Docket Item # 3  
BAR CASE # 2016-00325

**ISSUE:** Certificate of Appropriateness – Alterations and Waiver of Fence Height

**LOCATION:** 207 North Columbus Street

**Figure 2: Proposed Elevation**

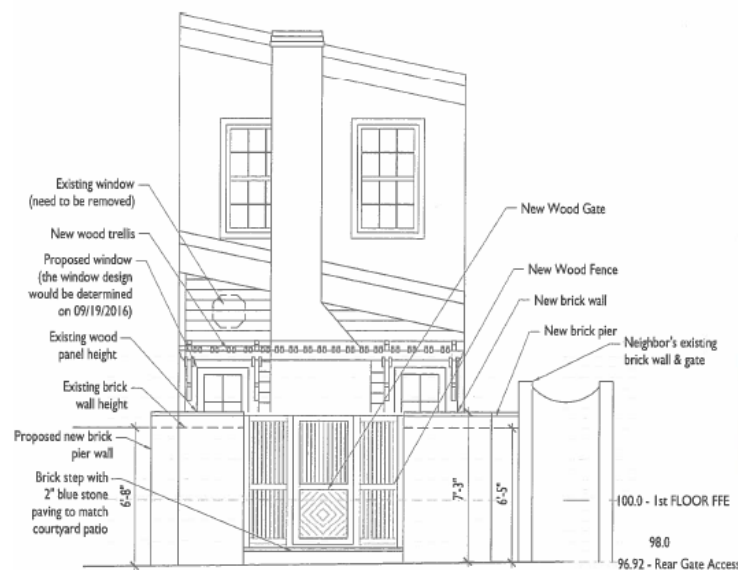
Staff has no objections to the enclosing of the existing octagonal window (2.1 sq. ft.) and removal of 16.18 sq. ft. of siding to create a new window. The new six-light window will be minimally visible from the public right-of-way and match the existing rear door's design and size. Additionally, the new window will make the rear façade more symmetrical. A Permit to Demolish is not required because less than 25 square feet of the wall surface is being removed or demolished.

The proposed re-design of the wood gate and fence will match the existing in height, ranging from 6'8" to 7'3", and remain in the same location. The new design will centralize the wood gate and add a brick step with 2" blue stone paving to match the courtyard patio. Section 7-202(C) of the zoning ordinance permits both Boards of Architectural Review to waive the permitted fence height "where the board finds that a proposed fence would be architecturally appropriate and consistent with the character of the district." While there are many areas in the districts where rear fences over six feet in height are not appropriate, staff finds that a taller fence is appropriate in this particular area. Staff measured the adjacent fences and noted that they range in height from 6'8" to 7' to 7'7". As these residential properties immediately abut the five-story post office building and its rear parking area, it is architecturally appropriate in this location to have taller fences. The rear forms of Church Row all remain visible and legible from the public way. Therefore, staff recommends approval of the fence and granting of the waiver of fence height to permit the fence to be a maximum of 7'3".

The *Design Guidelines* state that chimneys and flues are important functional elements of a building and provide visual variety to the roofline. Painting of a brick chimney for aesthetic purposes is uncommon within the historic district and by past practices not supported by staff. Because the chimney is located on the 1986 addition, painting it is a design issue rather than a historic preservation issue. Staff was unable to identify examples of painted chimneys on wood-frame buildings and does not support the proposed painting, noting that it also creates future maintenance issues.

The proposed new wood trellis will project 2'-9" into the rear yard and is 80% open. The new wood trellis is stylistically compatible and appropriate in scale.

Staff recommends approval of the application with the condition that the existing brick chimney remain unpainted.
